INITIAL FIRE SAFETY INSPECTION REPORT

Mango Tex Limited

Date: 23-September-2025

Table-1: All structures under this ID

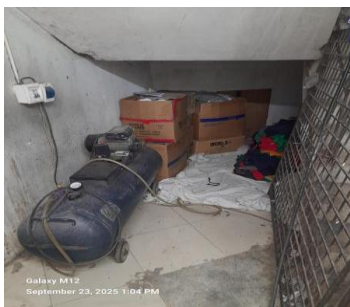
SI No.	Category	Findings	Required Action	Remediation Time Frame
F-01	Fire Rated Construction	<p>Rooms used for storage of combustible materials are not separated from the surrounding occupancy(production)</p> <p>Location: First floors of the production building</p> <p>Non-compliance reason: Unprotected opening & installed non-listed fire doors.</p>	<p>Rooms used for storage of combustible materials shall be separated from the surrounding occupancy with a minimum 1 hour construction in accordance with section 3.4.2.1.5 of RSC Technical Guideline (Standard).</p>	Within 3 Months

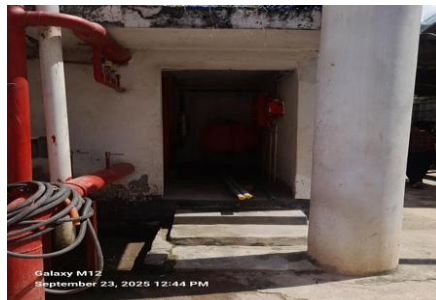
F-06	Fire Rated Construction	<p>The fire pump room is not provided with adequate fire separation.</p> <p>Location: Fire pump room Non-compliance reason: Unprotected opening(distance 5 feet) from production on ground floor west side</p>	<p>Provide fire pump room with 2 hr. rated fire separation when building is not fully sprinklered and 1 hr. rated fire separation when the building is provided with automatic sprinklers in accordance with NFPA 13.</p> <p>Or,</p> <p>Physically separate the pump room from the protected building by a minimum of 50 ft. (15.3 m) in accordance with NFPA 20.</p> <p>Provide direct access from the outside or provide a 2-hr enclosed passageway from an enclosed stairway or exterior exit.</p>	Within 3 Months
------	-------------------------	---	---	-----------------

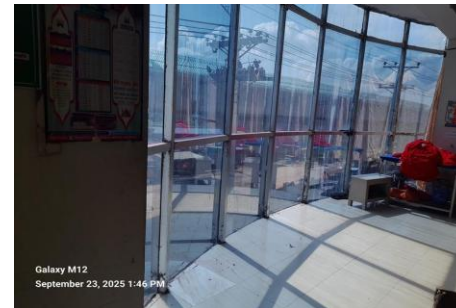
F-12	Fire Rated Construction	<p>Unprotected openings in the exterior wall in two consecutive floors lying within 1.5 m and vertical spread of fire is not restricted.</p> <p>Location: West side of the production building</p>	<p>Provide flame barriers as similar as sunshades or cornices or projected wall at least 750 mm from the external face of the exterior wall.</p> <p>The flame barrier shall have a fire resistance rating of not less than three-fourths hour.</p> <p>For Interim Building, BNBC 2006 Part III chapter 3 clause 3.1.7.2</p>	Within 6 Months
------	-------------------------	---	---	-----------------

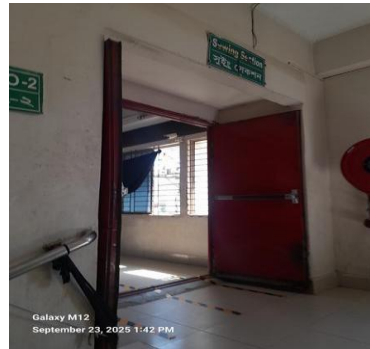
F-14	Means of Egress	<p>The exit stair enclosures are not separated from work areas and other spaces on each floor by fire-rated construction.</p> <p>Location: All three exit stairs of the production building.</p> <p>Non-compliance : 1. Due to unprotected opening at all floors of the east side stair</p> <p>2. Non-listed fire doors of the W-N & W-S side of the all stairs</p>	<p>The exit stair enclosure shall be provided with a minimum of 2-hr. fire resistance rating for buildings 4 or more stories. Provide 1.5 hr. fire rated door and seal all penetrations and openings by 2 hr. fire rated fire rated barrier construction for building with 4 or more stories in accordance with section 6.3.1.2 of RSC Technical Guidelines (Standard)¹ V1.0.</p> <p>Provide a fire-resistive rated assembly between the exterior exit stairs and the building up to 10 ft. beyond the end of the stair to achieve the required separation. The rated assembly shall be approved and/or designed by a qualified fire protection engineer.</p> <p>Ensure that the fire doors are self-closing and positive latching and that they are provided with fire exit (panic) hardware where serving production floors. If fire doors are required to be held open for functional reasons, provide automatic closing devices tied to the fire alarm system.</p> <p>Keep proper datasheet & certifications for installed fire doors & accessories on-site for verification. The clearance under the bottom of a door shall be a maximum of 3/4 in. (19 mm)..</p>	Within 3 Months

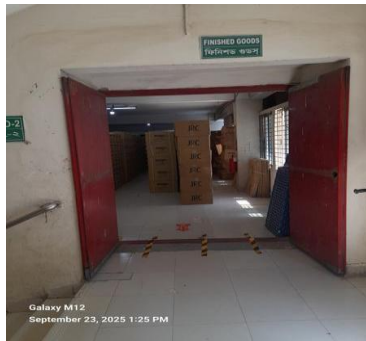
F-15	Means of Egress	<p>Unsealed penetrations and openings are located in exit stair enclosures.</p> <p>Electrical cable passing through the exit enclosure.</p> <p>Location(s): W-N side exit stair on ground floor of the production building</p>	<p>No other penetration into and through the exit enclosure except for fire alarm equipment electrical raceway, required exit doors, sprinkler piping, standpipes, and electrical conduit serving the exit enclosure is permitted in accordance with section 6.14.4 of RSC Technical Guidelines (Standard)¹ V1.0. So, relocate the electrical wires/raceways to somewhere else avoiding the exit enclosure, and seal the created unprotected openings with a minimum of 1.5 hours listed/certified fire-rated materials. Installation shall be as per manufacturer published installation guideline and the certification authority guideline to ensure the fire-rating. Or seal the penetration by 2-hr masonry construction.</p>	Within 3 Months

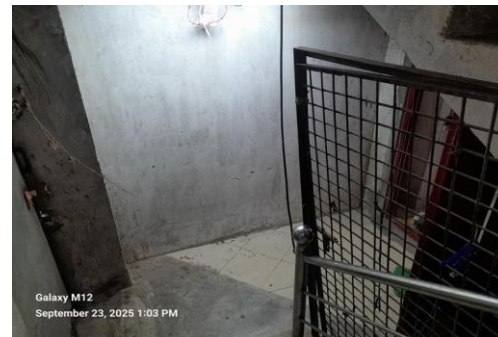
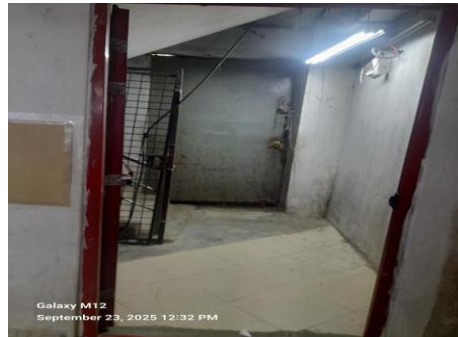
F-24	Means of Egress	<p>Exit stair(s) terminates the occupants inside the building which does not comply with section 6.17 of RSC Technical Guidelines (Standard)¹ V1.0.</p> <p>Location: Production building Level of Discharge: East side exit stair at ground floor</p>	<p>Exits shall discharge directly to the exterior of the building unless meeting the requirements of 6.17.2 or 6.17.3 as per RSC Technical Guidelines (Standard)¹ V1.0.</p>	Within 3 Months
------	-----------------	---	--	-----------------

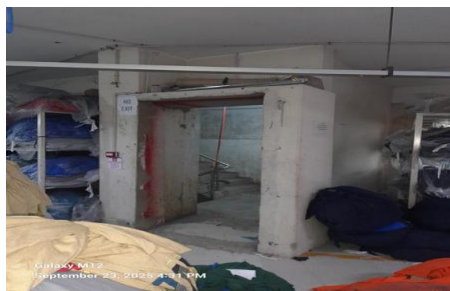
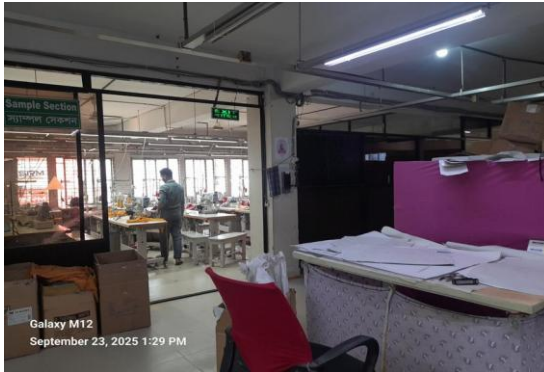
F-33	Means of Egress	<p>Parapets are provide less than 42 inch in occupiable roof.</p> <p>Available Height: 40 inch</p> <p>Location: Production Building.</p>	<p>Provide parapets or guards with a minimum height of 1067mm (42 inch.) in accordance with RSC Technical Guidelines (Standard)¹ V1.0 Section 6.12</p>	Within 3 Months
F-34	Means of Egress	<p>Building does not have stair/floor level designation signs at required locations on all floors.</p> <p>Location: Production Building.</p>	<p>Provide stair designation sign at each floor entrance from the stair to the floor in English and Bengali. Signs shall indicate the name of the stair and the floor level. Signs shall be posted adjacent to the door in accordance with RSC Technical Guidelines (Standard)¹ V1.0 Section 6.9.3.</p>	Within 1 Month
F-35	Means of Egress	<p>Exit sign not provided at exit.</p> <p>Location: All floor of the exit stair-3(east side) of the Production Building & all other structures.</p>	<p>Lighted exit signs shall be placed at entrance to an exit. Additional directional exit signs shall be placed throughout the facility anywhere the continuation of the egress is not obvious. Lighted exit signs shall be provided with either battery backup or uninterruptable power supply systems and shall be continuously illuminated at all times. Exit Sign shall provide in accordance with RSC Technical Guidelines (Standard)¹ V1.0 Section 6.11.</p>	Within 1 Month
